SKI-DOO, SEA-DOO, CAN-AM New Mpi-3 Interface Card Rev1_000106637 SER00Y015S00 en

Bulletin no: <u>► Multi-brand </u> (sbs2015-005_rev1 en JL)

Subject: New MPI-3 Interface Card

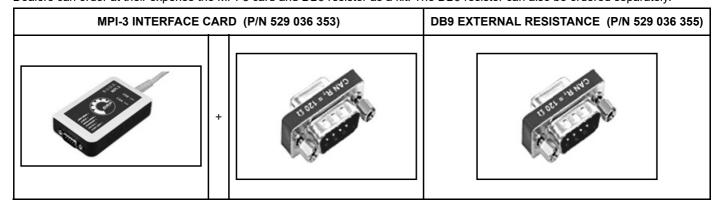
BRP is introducing a new MPI-3 interface card to replace the current MPI-2 card, which will continue to function on all BRP vehicles. MPI-3 card improvements over the MPI-2 card are:

- A more robust casing
- A faster processor significantly reducing ECU reprogramming time
- An external DB9 resistor that can be added or removed from the MPI-3 interface card, improving connectivity on *some* BRP vehicles (See BRP B.U.D.S. CHART).

NOTE: The MPI-2 card had a resistor built into it. However, on newer vehicles, this resistor is already included in the vehicle harness. Since having the extra resistor could cause communication issues, it has been designed as a separate unit of the MPI-3. For specific vehicle application, consult the latest *BRP B.U.D.S. CHART*.
